Re: Response to the BOE's Technical Memo  
Council File No. 05-0173

# **RESPONSE TO THE TECHNICAL MEMORANDUM ON BICYCLE AND PEDESTRIAN FACILITIES ASSESSMENT**

# Technical Memorandum

**To:** City of Los Angeles Bureau of Engineering  
**From:** Alejandro Angel, PhD, PE, PTOE and Arief Naftali, PE, TE  
**cc:** Anissa Voyiatzes, PE  
**Date:** May 28, 2015  
**Re:** Bicycle and Pedestrian Facilities Assessment

Figure 4 Comparison of Existing and Proposed Pedestrian Facilities

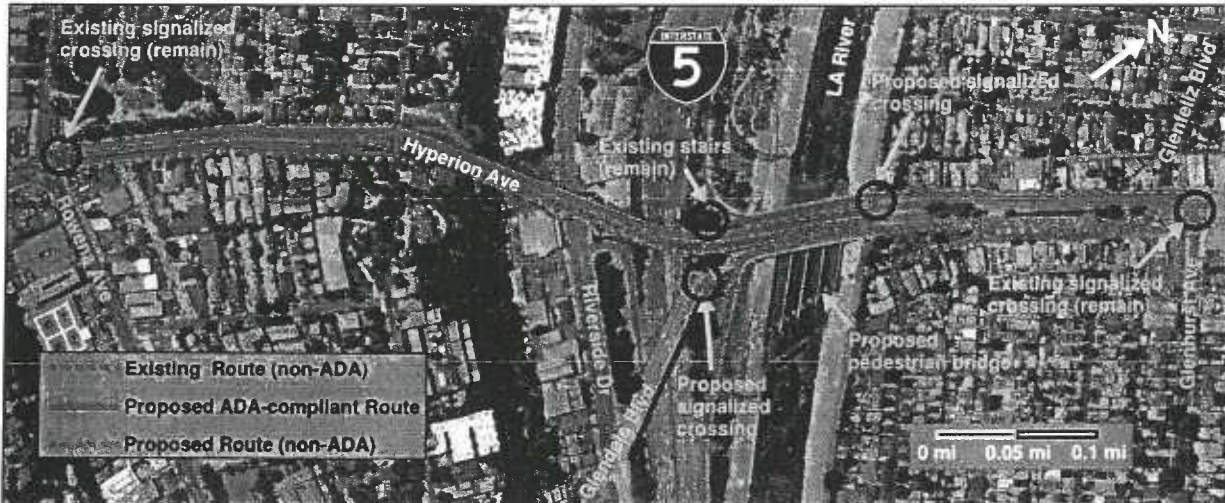
3. Longer travel paths for pedestrians starting or ending their trips on the east-side of Glendale Blvd between the Los Angeles River and Glenhurst Ave exist. The disadvantages listed in the TM incorrectly minimize the estimates of travel times for both able-bodied and disabled pedestrians. It fails to recognize that much of the pedestrian activity will be on a significant grade. Assuming the travel distances are correctly indicated in the TM, the significant travel time impacts on pedestrians are more correctly reflected as shown.

- Able-bodied: Longer travel time of 2.6 minutes at 2 ft/s walking speed for 310 ft distance.
  - Disabled: Longer travel time of 17.2 minutes at 1.5 ft/s for 1550 ft distance. This travel time can be compounded due to the 5 percent grade in the Atwater to Silver Lake travel path.

The disadvantages in the TM's recommended improvements are based on incorrect assumptions and miscalculations. By having a sidewalk on only one side of the road, there is a significant safety risk of conflicts between bicyclists and pedestrians walking on the bike lane along the east side of Hyperion Avenue between Waverly and Glenfeliz/Glenhurst .
